### **Addendum #2 – January 15, 2025**

#### **Twin Cities Rail Trail Phase III**

**ITEM 1-2: LANDSCAPE DETAIL SHEET L5.0**

**2 GRANITE PAVING**

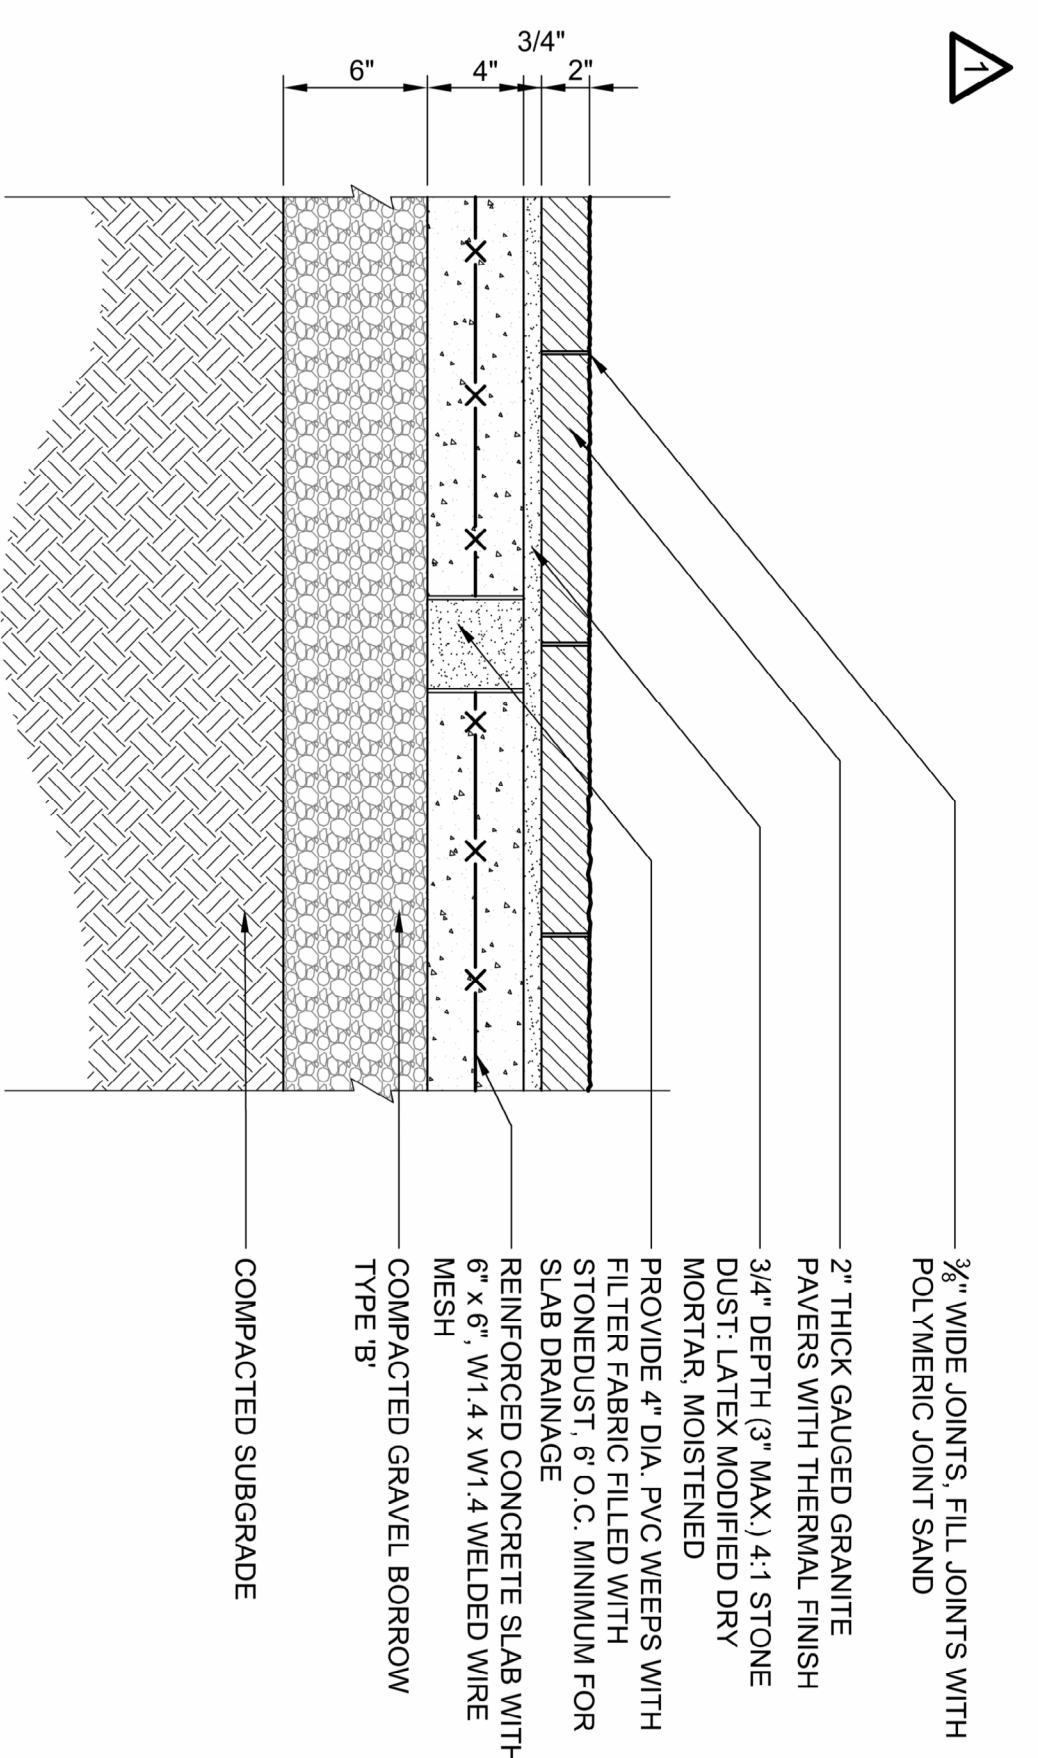
**DELETE** Landscape Detail Sheet L5.0, and **REPLACE** with revised Landscape Detail Sheet L5.0, attached hereto as Attachment B.

**Q1A** The granite pavers are shown in Detail 2 – Granite Paving on plan sheet L5.0. The following questions are for these pavers: Note 1 for this detail specifies a 2-1/2" thick minimum paver, however the detail shows a 2" thick paver. Please advise how thick the paver is to be.

**A1A** **Granite Pavers shall be 2" thick, gauged. See attached, revised detail sheet L5.0.**

NOTES:  
1. ALL PAVERS ARE 2" THICK, MIN. REFER TO SPECIFICATIONS FOR ADDITIONAL REQUIREMENTS.  
2. ALL EXPOSED EDGES OF GRANITE SHALL BE THERMAL FINISH.  
3. JOINT SAND COLOR TO BE SELECTED FROM SAMPLES.  
4. INSTALL 3/4" EXPANSION JOINT AT ALL VERTICAL STRUCTURE INTERFACE.  
5. INSTALL 3/8" EXPANSION JOINT AT ALL PAVING JOINTS, 3/8" O.C. MIN.
